HCCSC Horace Mann Elementary HVAC Replacement

Project # 2025.0014

9-28-2026

ADDENDUM NO. 01

TITLE
FIRST FLOOR MECHANICAL PLAN - UNIT B

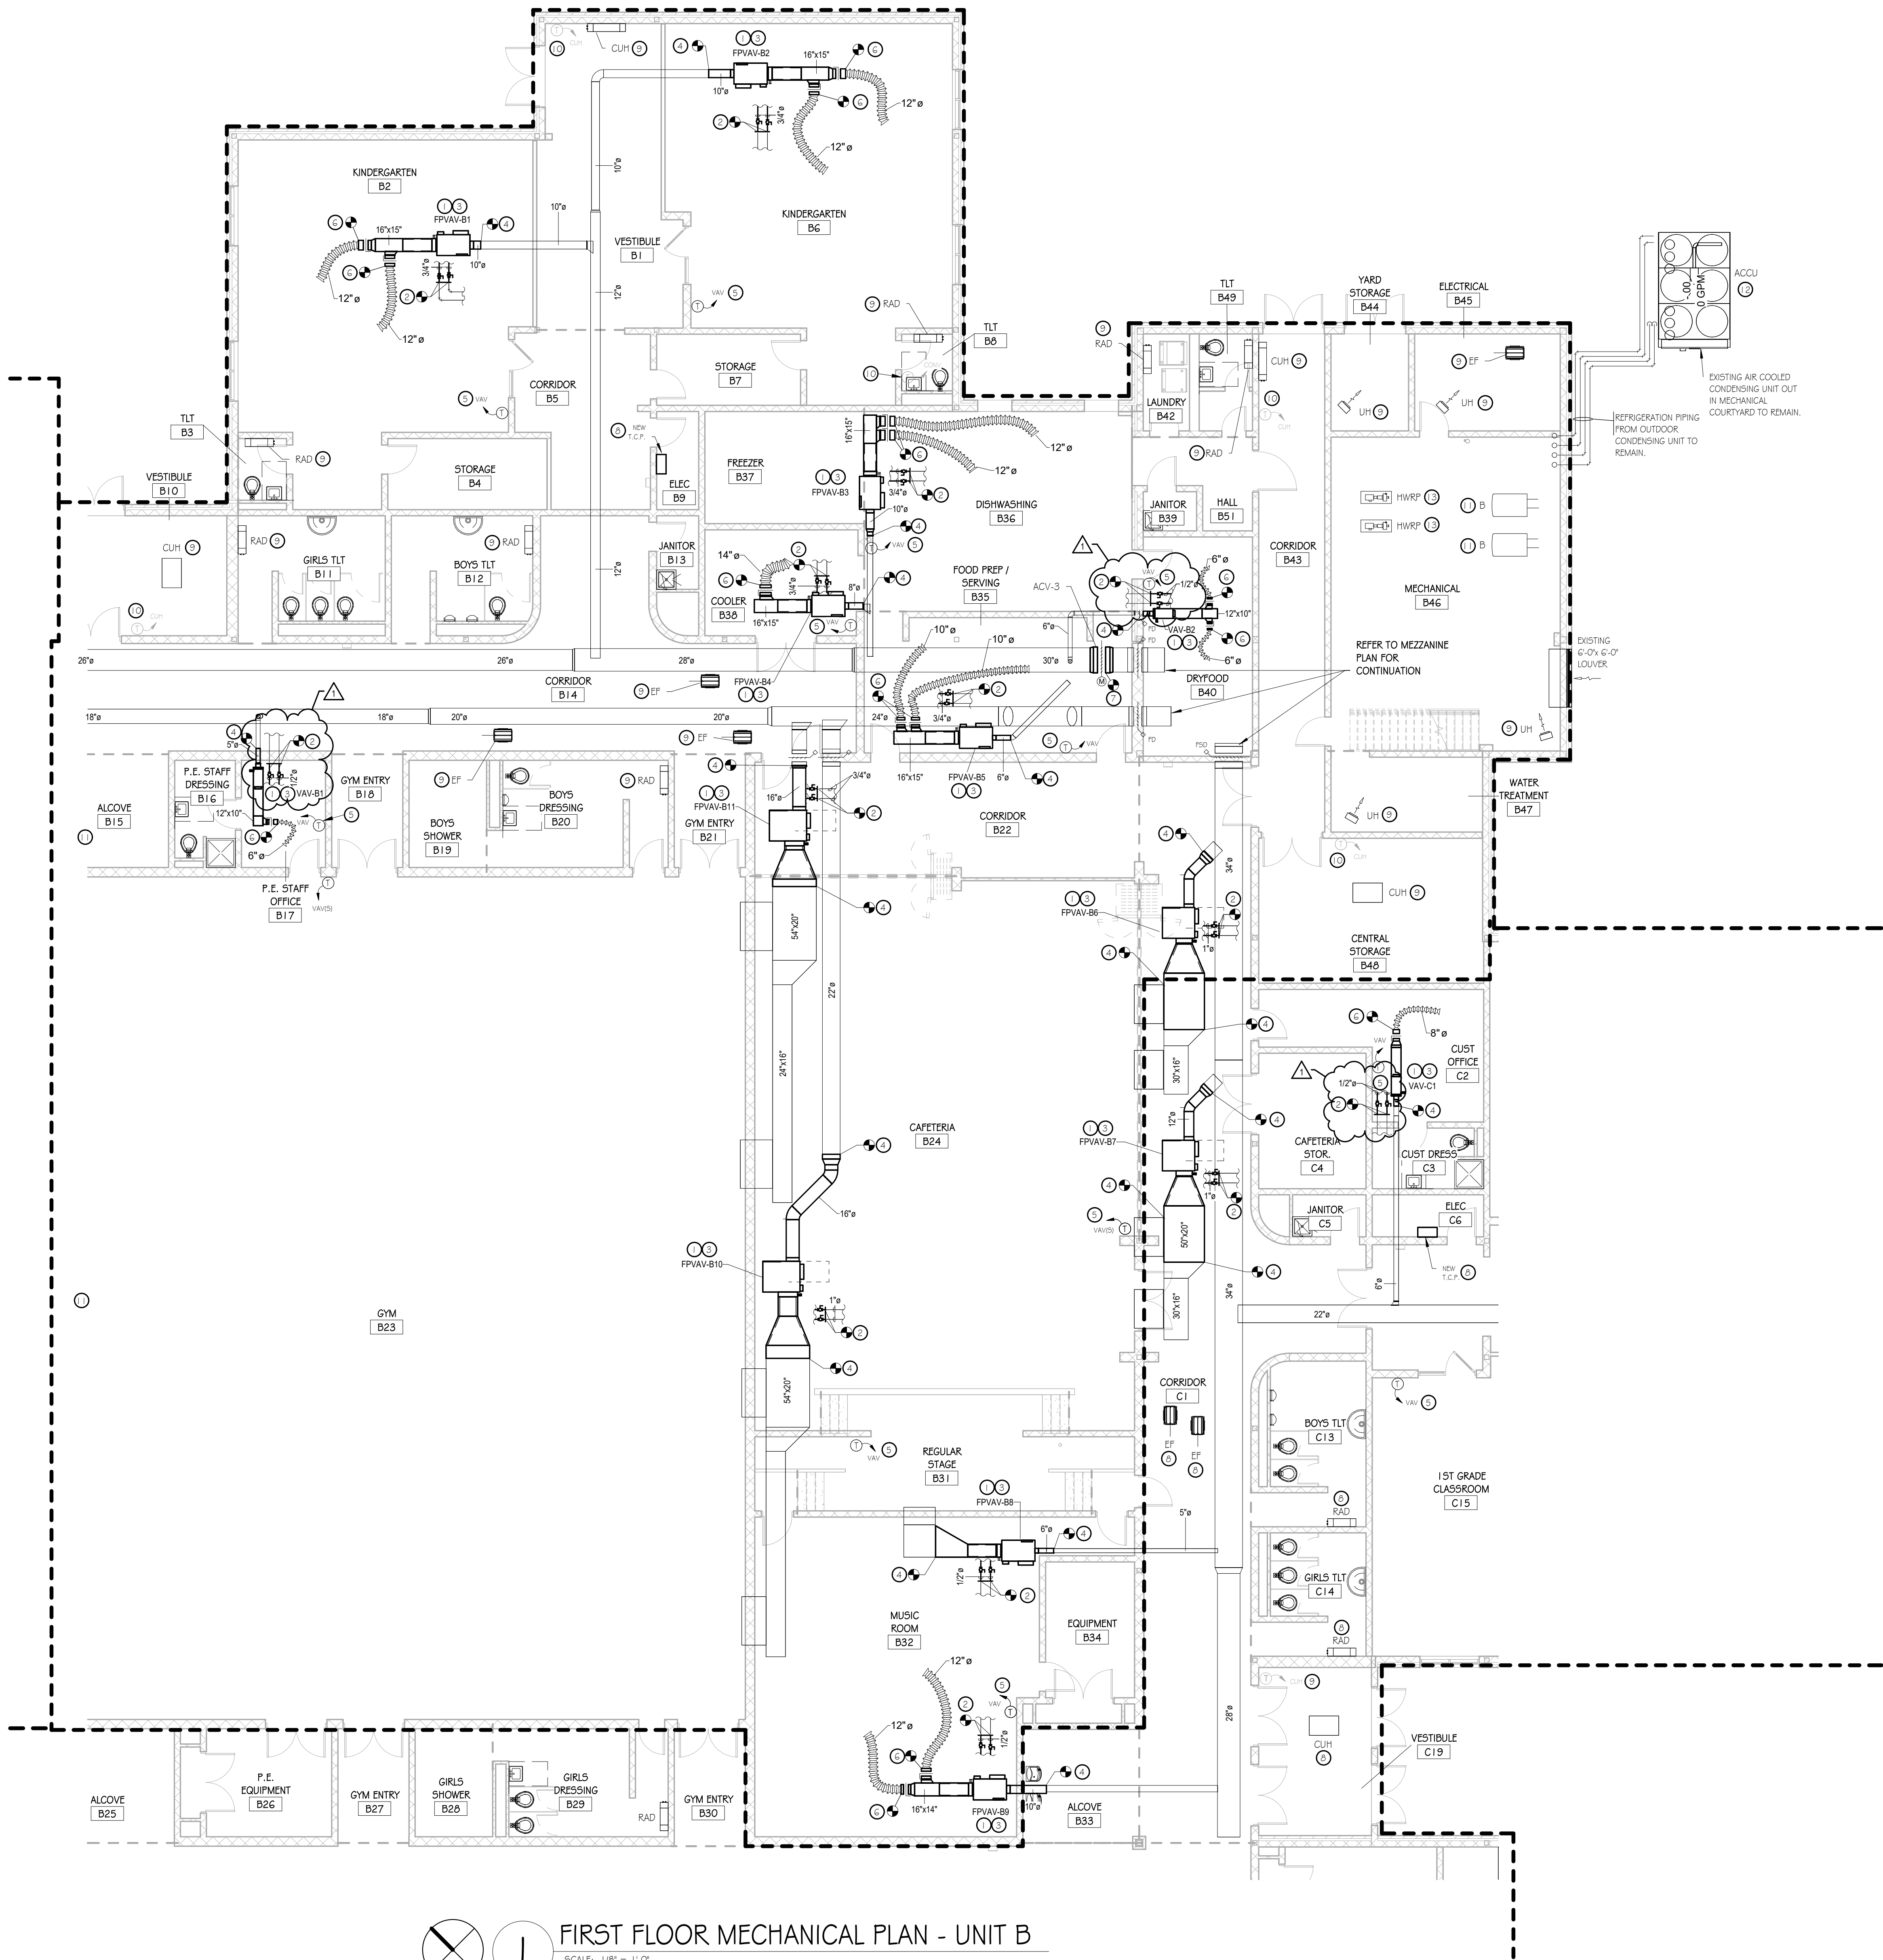
Item: A-1.9
Location: Drawings
Description: Replace existing drawing sheet M1-1B First Floor Mechanical Plan – Unit B, dated 9-21-2026, with Revised drawing sheet M1-1B First Floor Mechanical Plan – Unit B, dated 9-28-2026.
Changes: **Select VAVs that don't have fans: add piping information. Shows all piping reconnections to units VAV-B1, VAV-B2, and VAV-C1, accordingly.**
